**TOWN OF GRAY**  
**PLANNING BOARD**  
**AGENDA • FEBRUARY 8, 2024**

Aerie Estates Amendment to Eagles Ridge Subdivision – Preliminary and Final Plan Review

A request by Sebago Realty, LLC, represented by D.H. Roma Consulting Engineers, for preliminary review and final plan review of a proposal to create a 14-lot residential open space subdivision on the 41+/- acre parcel off Eagles Nest Road, at Tax Map 63, Lot 35-24, on the remaining land in the Eagles Ridge Subdivision, in a Rural Residential and Agricultural zoning district. The proposal is subject to major subdivision plan review.

FOOT PATH DETAIL

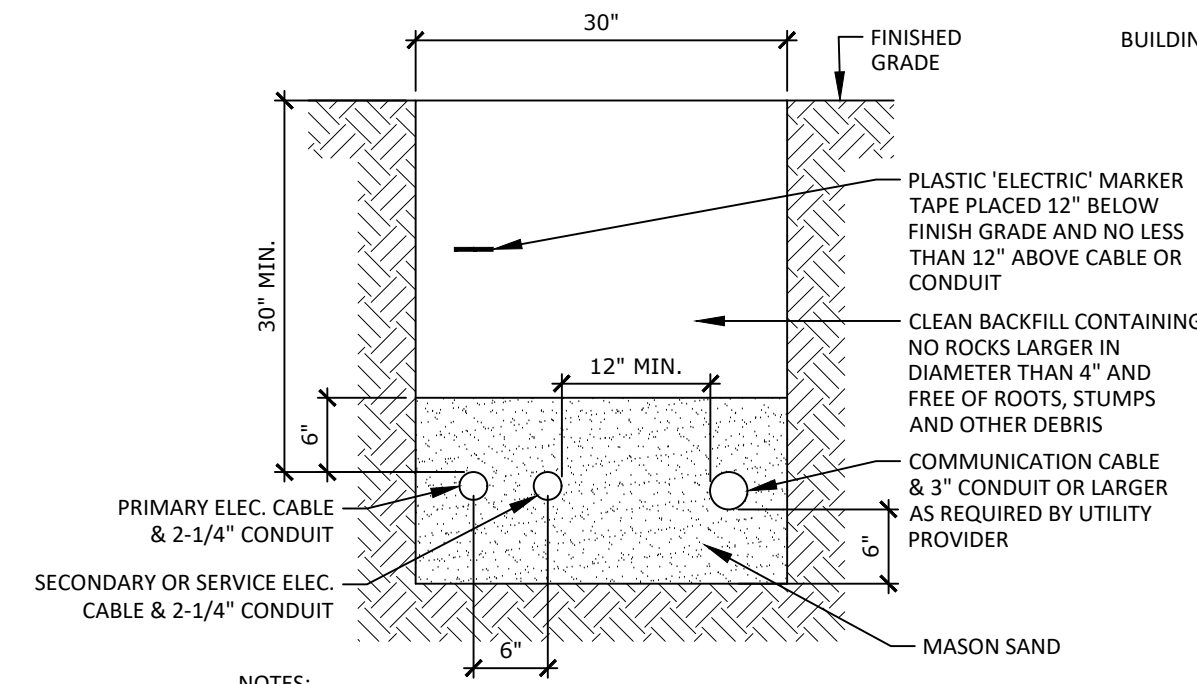
Comments from Town Planner:

5. The detail for the footpath shown on Sheet D-2 has been revised to reference Open Space A.
6. We have added the potential vernal pool location on the abutting open space area of Eagles Ridge Subdivision and noted the associated 100-foot and 250-foot regulated areas that extend into our project on Lot 14. The stream with associated 75-foot regulated area has also been added to Lot 14. There is no proposed development shown on our plans within any of these additional regulated areas.
